UNITED STATES OF AMERICA
NUCLEAR REGULATORY COMMISSION²⁶

AFFIDAVIT OF ROBERT H. TURNER

Subject: Evaporation Pond
Palo Verde Nuclear Generating Station
File: 80-003-028.6/CM-020

SUBJECT: Palo Verde Evaporation Pond (7-54)
General description and hazard
classification.

Hypalon liner placed on the upstream slope of the south dike at the southwest corner. View from West Dike.

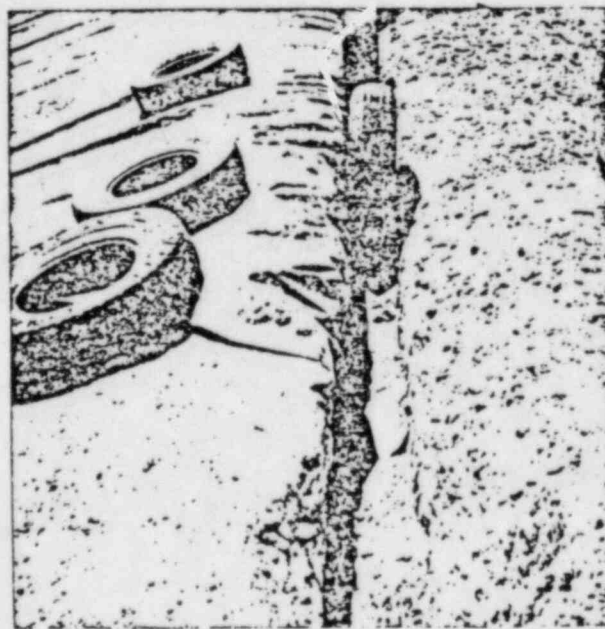
In my opinion, the trench depth giving a soil cover of 12" is not sufficient to prevent movement or the downward drag of the liner due to settlement, wave action and the hydrostatic forces.

I discussed this with Dick McGregor at the site and Joe Kanovich (both of APS) after my return to the office and asked them to look into the matter before it is too late. To insure sufficient anchorage we would require that the manufacturer's specifications of the 18" minimum trench depth be followed. Further, the contractor is presently backfilling the trench without compaction. I suggested, 6" layers of uncompacted thickness should be hand tamped with proper care taken to protect the liner from damage. Joe Kanovich told me he will discuss these points with Goodrich and Bechtel staff and call me back.

Discussed with Dick McGregor and Dick Anderson the discrepancy between the manufacturer's specifications and the construction drawings on the required depth of trench to terminate upper end of the hypalon liner near the upstream crest. It was finally agreed that Bechtel will issue the work stoppage notice (NCR) to the contractor and refer the problem to their design office in Downey, California to verify if the 12 inch depth of trench (as is being built according to the drawings) or the manufacturer's specifications requiring 18" depth should be followed. The hypalon lining work was, as such, stopped from the afternoon of 9-23-81.
